Re: COID's Siphon Power Plant; DEQ Water Quality Determination in Support of LIHI Certification

Memorandum

**To:** File **Date:** January 15, 2009  
**From:** Paul DeVito, Hydropower Specialist   
**Section:** Eastern Region, Bend Water Quality  
**Subject:** COID application for LIHI certification and request for DEQ water quality assessment for the Siphon Power Project

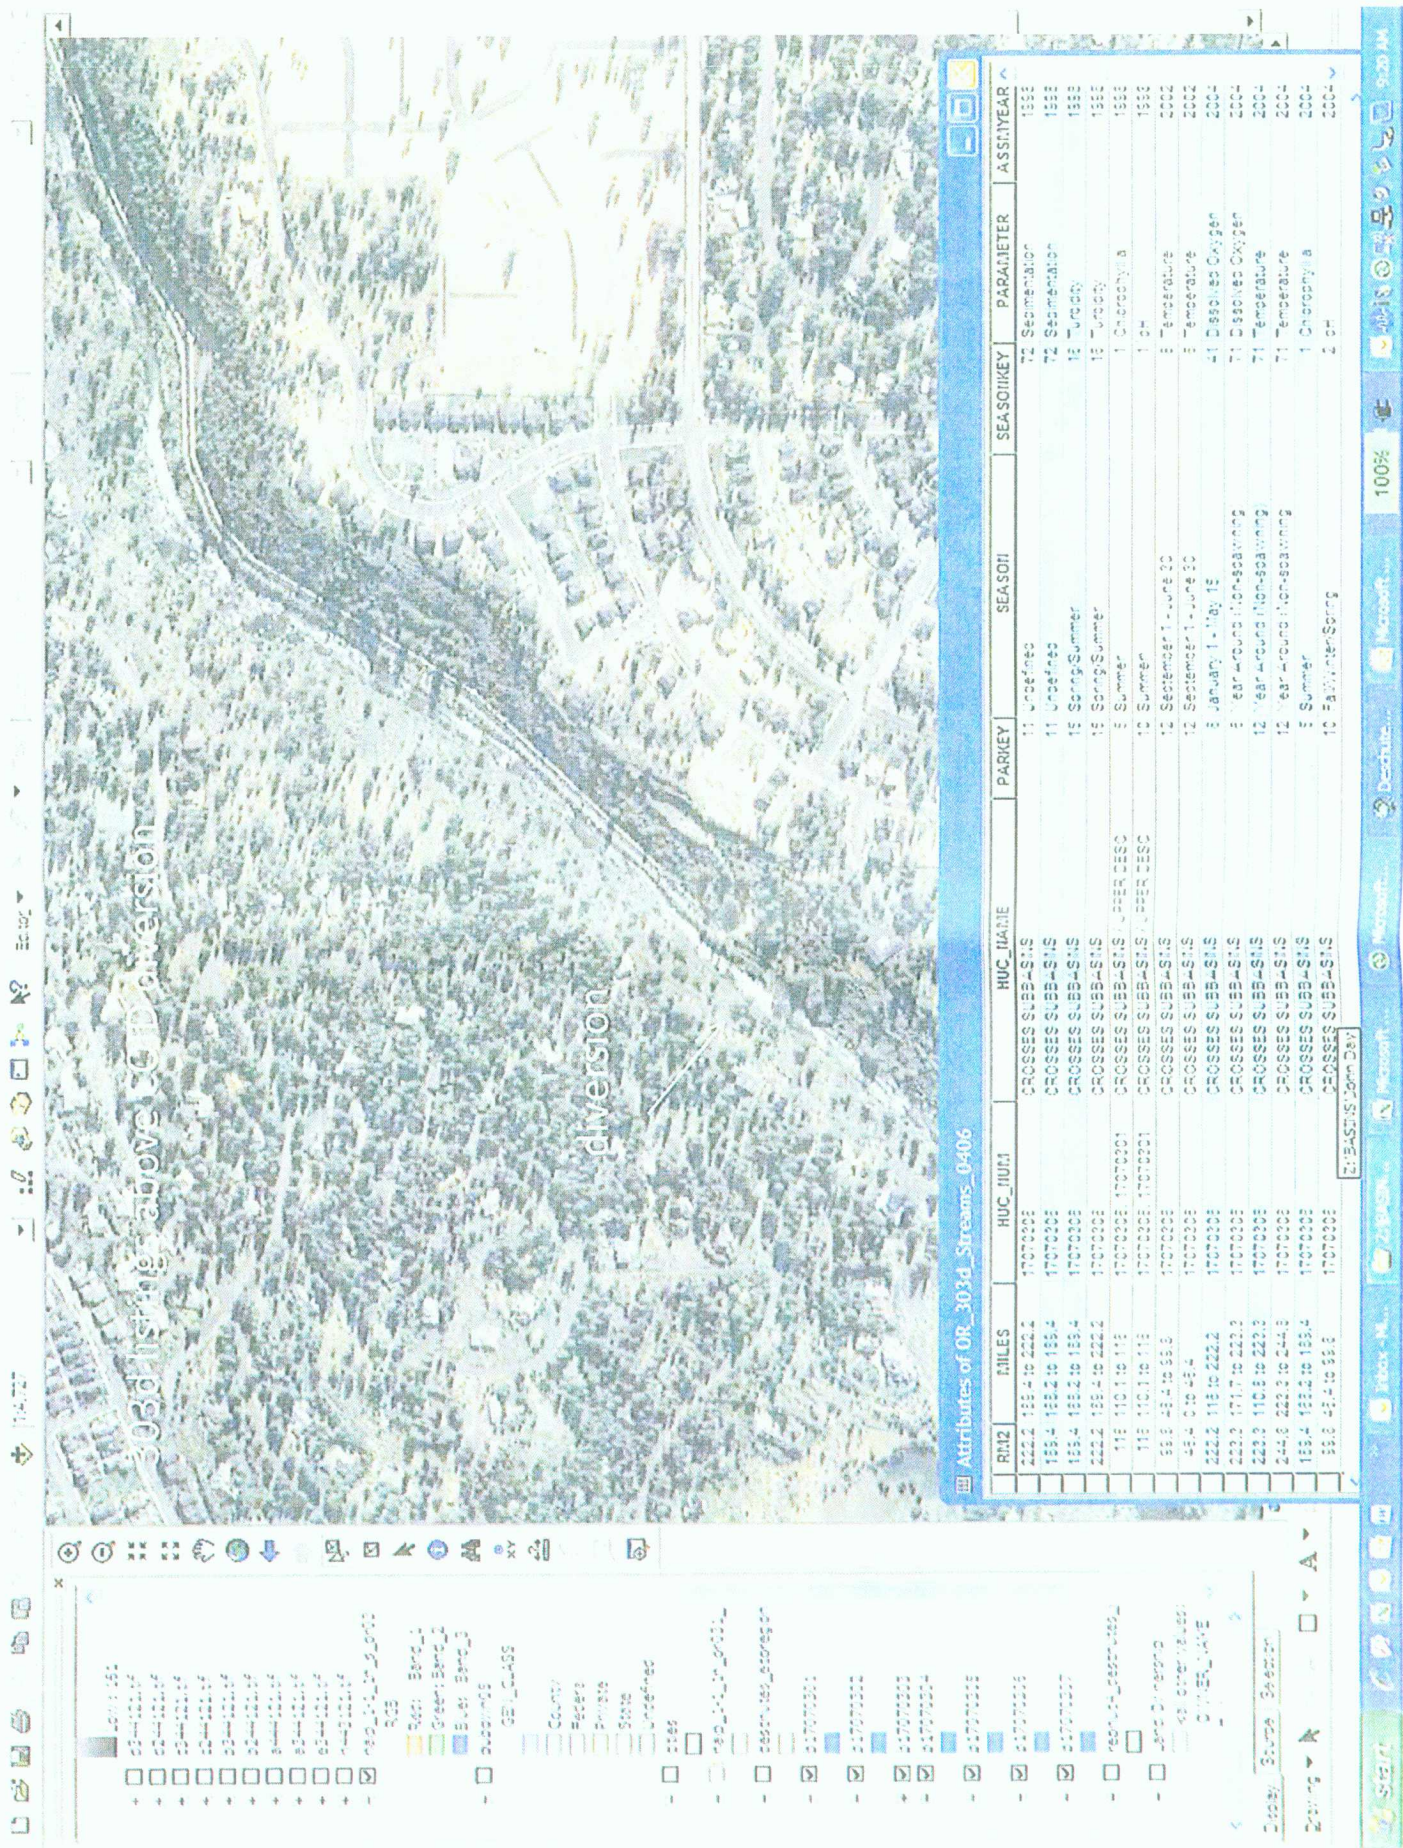
In order to evaluate this concern for potential Project-related warming of the river (contribution to violation of the temperature standard and 303(d) listing), I examined available DEQ data for a Forward Looking Infrared (FLIR) survey of the river that was performed on July 25, 2001 (attached). This date corresponds to the summer season during which the Project would likely have greatest potential of contributing warming to the river. Review and calculation of Bureau of Reclamation Hydromat archival flow data reveals the following estimated flow values for the day of the FLIR flight: 1419 cfs in the river immediately upstream of the diversion; 800 cfs diverted out of river; 619 cfs retained in the river immediately downstream of the diversion; 493 cfs of the 800 cfs diverted was subsequently split off and routed to irrigation; 307 cfs of the 800 cfs diverted was routed to the SPP powerhouse and discharged back to the river. Thus, on July 25, 2001, the maximum amount of water was being diverted out of the river corresponding to the 800 cfs pipe capacity of which just over 300 cfs was being routed to the powerhouse and back to the river approximately 1.5 miles downstream.

It appears, based upon both examination of the color-coded FLIR temperature photos and the graphic representation of longitudinal temperature change that there is no net temperature increase within or immediately downstream of the Project's bypass reach. Thus, DEQ concludes that the Project is not contributing to the Deschutes River's 303(d) listing for temperature.
